Re: S/D 88-108 - MEDITERRANEAN PLAZA 2ND ADDITION

At the regular meeting of the Subdivision Committee of the Metropolitan Area Planning Commission on Thursday, November 15, 1990, the above captioned plat was considered. The action of the Committee was to recommend that this plat be approved subject to:

STAFF REPORT  
(Revised Final Plat)  
(Final Plat Approved 6/1/89;  
Preliminary Plat approved 1/12/89)

CASE NUMBER: S/D 88-108 - MEDITERRANEAN PLAZA 2ND

**MEDITERRANEAN PLAZA**

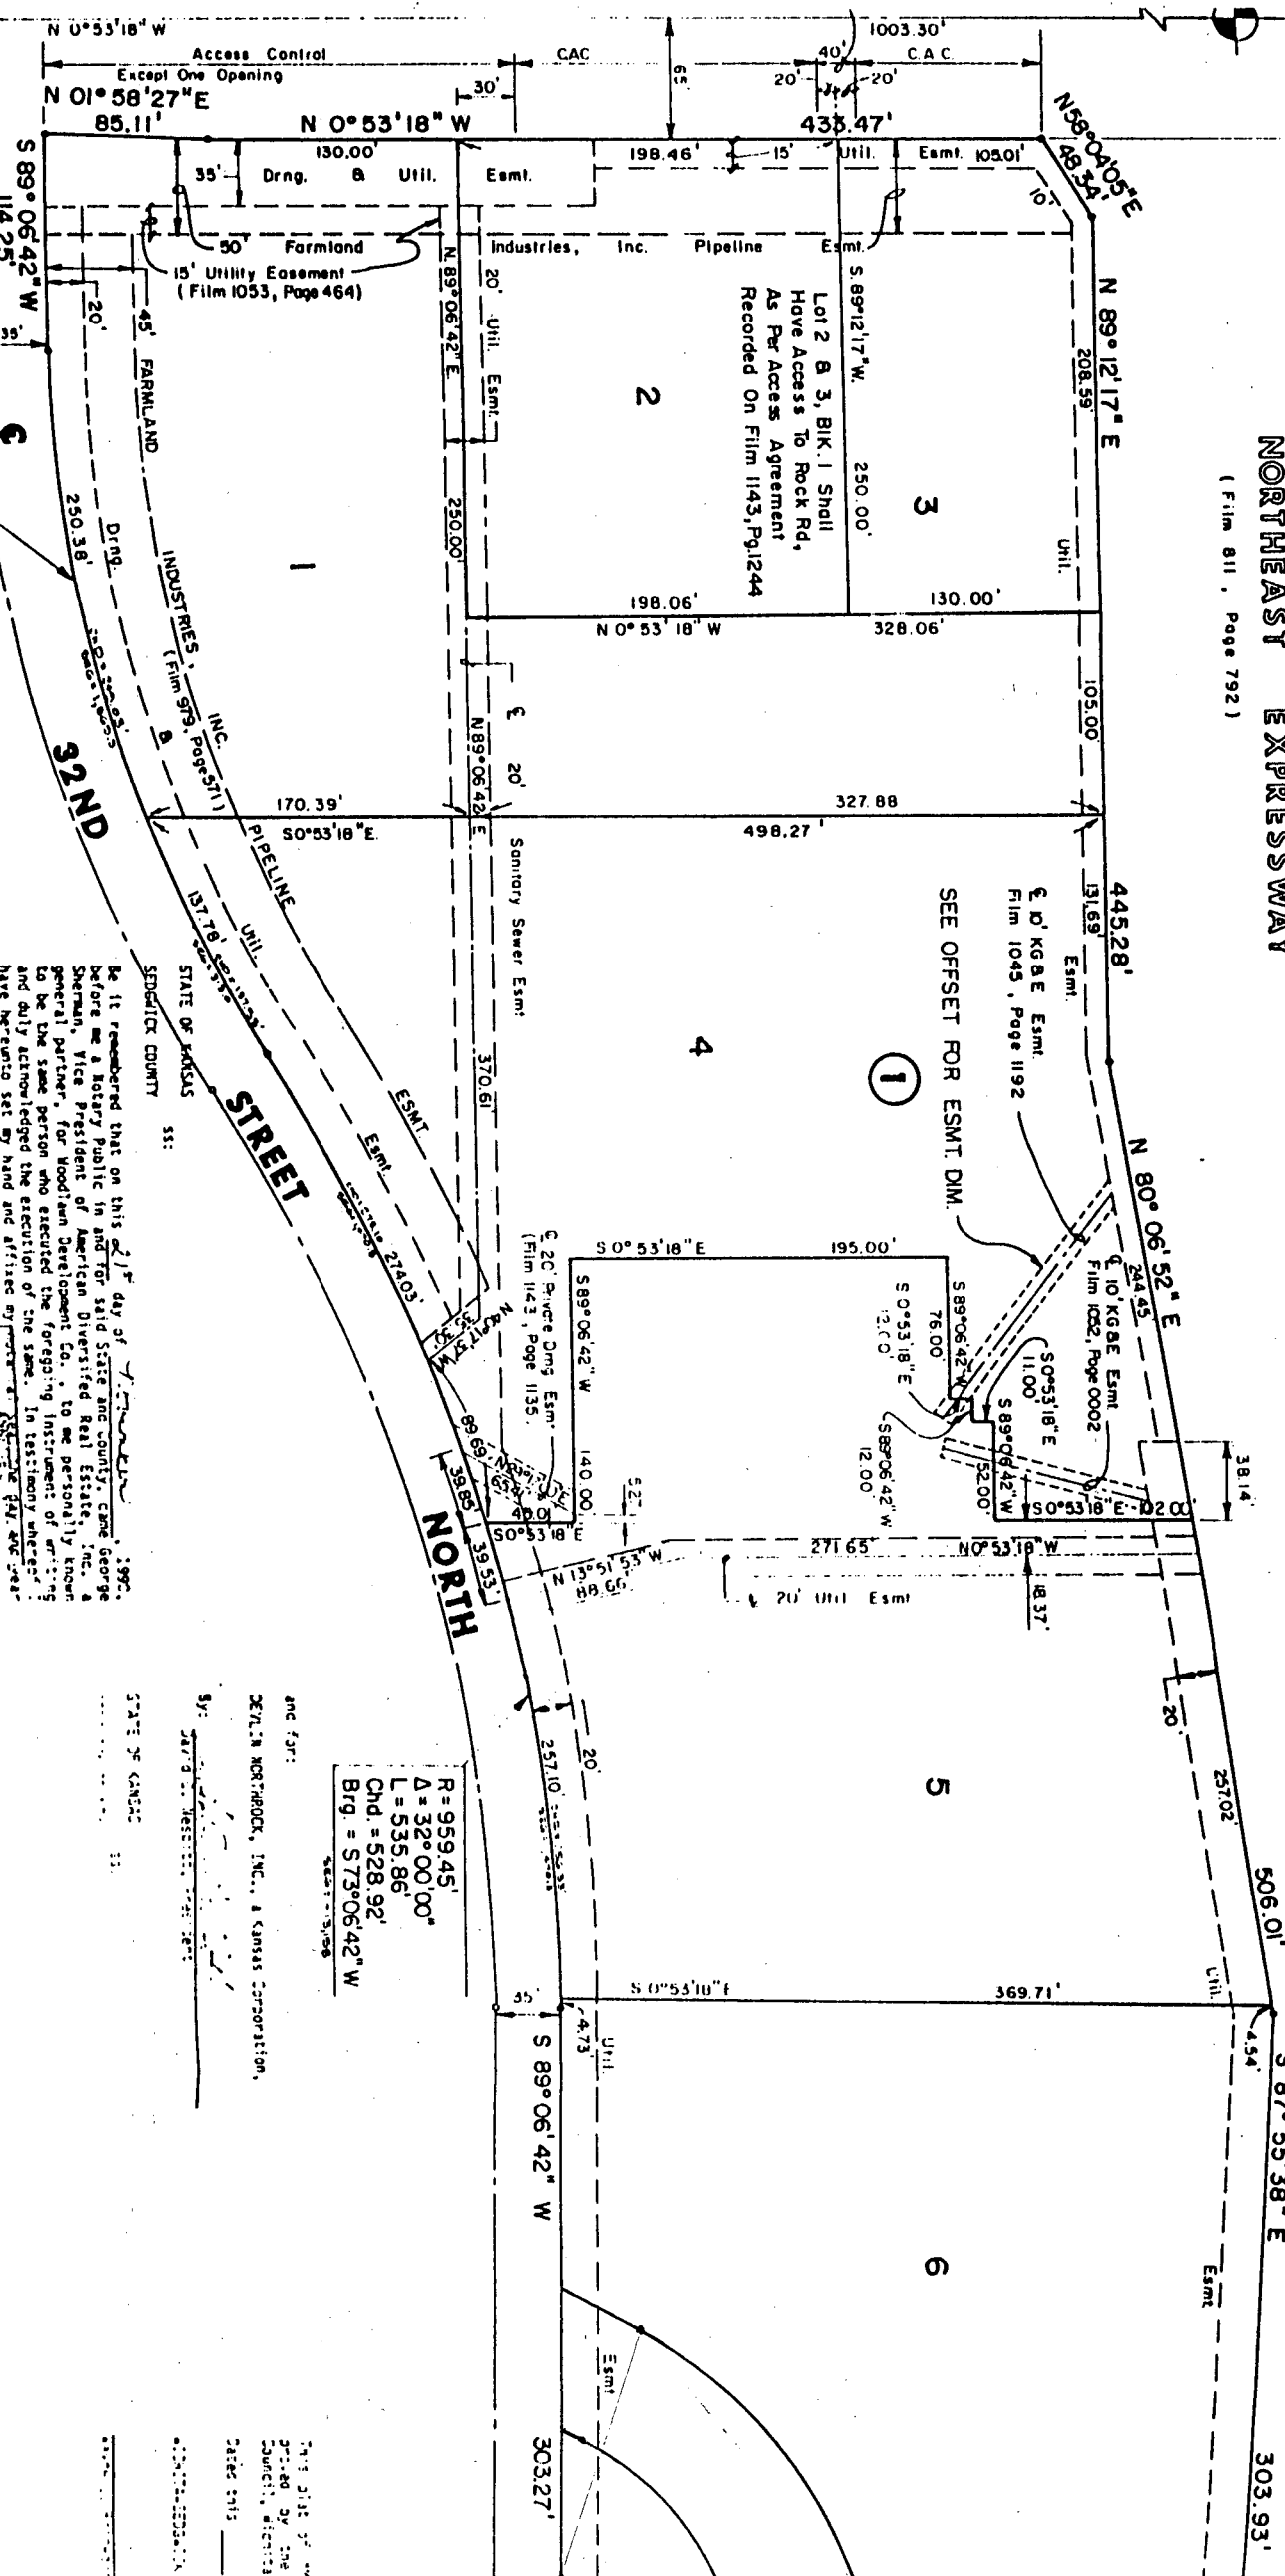
- C. On the face of the plat, the word "Complete" shall be deleted from the access control to lots 1, 2, and 3, since openings are being provided from these lots to Rock Road.

- D. The plattor's text shall also be amended in regard to the complete access control being established across the north line of this plat. Since no "Reserve A" is shown on this plat, reference to it should be deleted. Both the plattor's text and face of the plat can reference the proposed North East Expressway to the north of the site, or the text can simply note that complete access control is being dedicated across this site's (lots) north line.

- E. In order to better locate the K.G. & E. easements on lot 2, the drainage easement on lots 4 and 5 and the position where the sanitary sewer easement crosses lot 1 and 4's lot line, additional dimensions shall be provided from appropriate lot corners to these easements.

- J. A note shall be placed on the face of the final plat tracing which indicates that building setbacks between lots are per requirements of C.U.P.-188. The plat's text shall also note these requirements. The present reference to a C.U.P. on the final plat is inadequate.

- K. The City Council signature block shall be amended to indicate that the plat is accepted by the City "Council" not "Commission."
- L. The applicant shall install or guarantee the installation of all utilities and facilities which are applicable and described in Article 8 of the MAPC Subdivision Regulations.
